Access Compliance Report

Public Rights-of-Way

(Curb Ramps)

Intersection ID: 3242	Main Street: MALLARD_PINE_CT	Cross Street: SHELLY_PINES_DR	Location: SW
ADA ID: 0C38EE67EAB0	Ramp Type: Perp	Initial Pass/Fail: Fail	Overall Compliance: No
Severity Score: 37.5			
Codes/Mitigation Info/Possible Solution		Field Measurements/Component Compliance

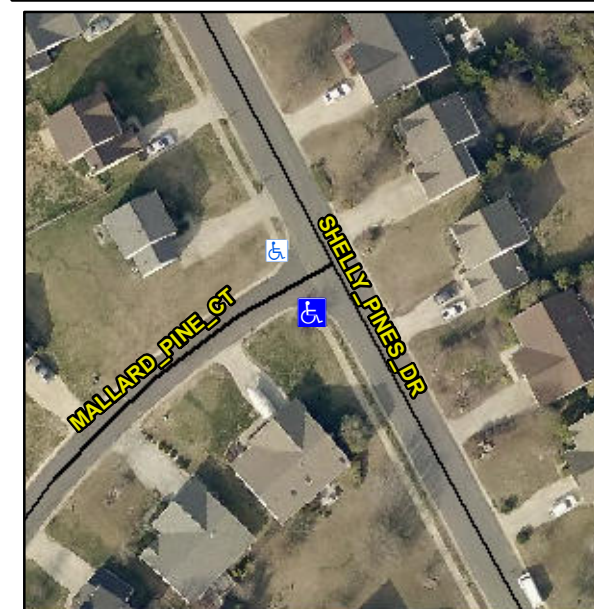
Not Found, R304.2.2, R304.5.3

Compliance	Description	Data	Compliance	Description	Data
N/A	Ramp Length (in)	49.0	No	Ramp Slope (%)	8.6
Yes	Ramp Width (in)	68.0	No	Ramp XSlope (%)	7.6
N/A	Flare Type LT	N/A	N/A	Flare Type RT	N/A
N/A	Flare Slope LT (%)	N/A	N/A	Flare Slope RT (%)	N/A
N/A	Flare Traversable LT?	N/A	N/A	Flare Traversable RT?	N/A
N/A	Landing Length (in)	N/A	N/A	DWS Provided?	N/A
N/A	Landing Width (in)	N/A	N/A	DWS Contrast?	N/A
N/A	Landing Slope (%)	N/A	N/A	DWS Length (in)	N/A
N/A	Landing X Slope (%)	N/A	N/A	DWS Full Width?	N/A
N/A	Landing Curb? (Y/N)	N/A	N/A	DWS Offset (in)	N/A
N/A	Shared Landing?	N/A			
N/A	Gutter Ponding?	N/A	N/A	Gutter Slope (%)	N/A
N/A	Gutter Lip Ht (in)	1.5	N/A	Gutter X Slope (%)	N/A
N/A	Painted X Walk1?	No	N/A	Painted X Walk2?	N/A
	X Walk 1 Direction	To N		X Walk 2 Direction	N/A
N/A	X Walk 1 Width (in)	N/A	N/A	X Walk 2 Width (in)	N/A
	X Walk 1 Slope (%)	3.5		X Walk 2 Slope (%)	N/A
	X Walk 1 X Slope (%)	10.8		X Walk 2 X Slope (%)	N/A

Remove & Replace Entire Ramp.
